**HISTORIC LANDMARK COMMISSION**  
**APPLICATION FOR A CERTIFICATE OF APPROPRIATENESS**  
**JULY 27, 2020**  
**C14H-1996-0003**  
**BARTHOLOMEW-ROBINSON BUILDING**  
**1415 LAVACA STREET**

Construct a mid-rise addition to the building.

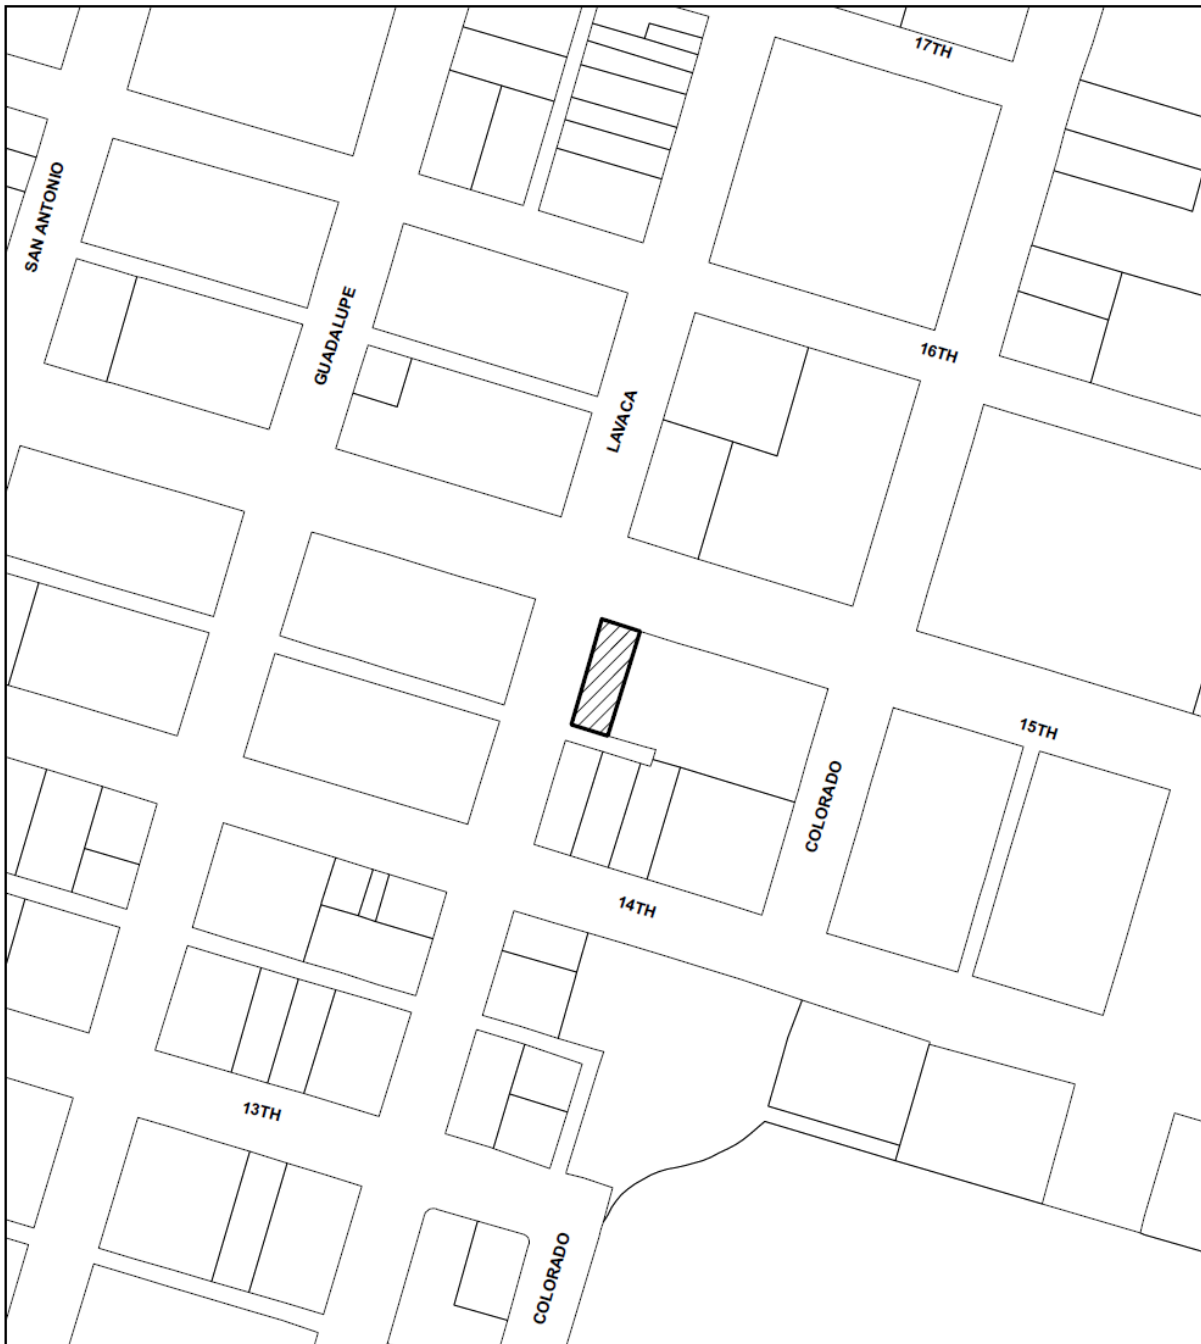
The Committee viewed the plans that showed only an 8-foot separation between the top of the cupolas and the base of the addition, and recommended increasing the distance as much as possible. While the Committee is not comfortable with the construction of mid- or high-rise additions to low-rise historic landmark buildings in general, they did express appreciation for the changes in design presented to the Committee over the course of several meetings and the clean lines that characterize this addition. The applicants have returned to the full Commission with the instant set of drawings with the changes requested by the Committee.
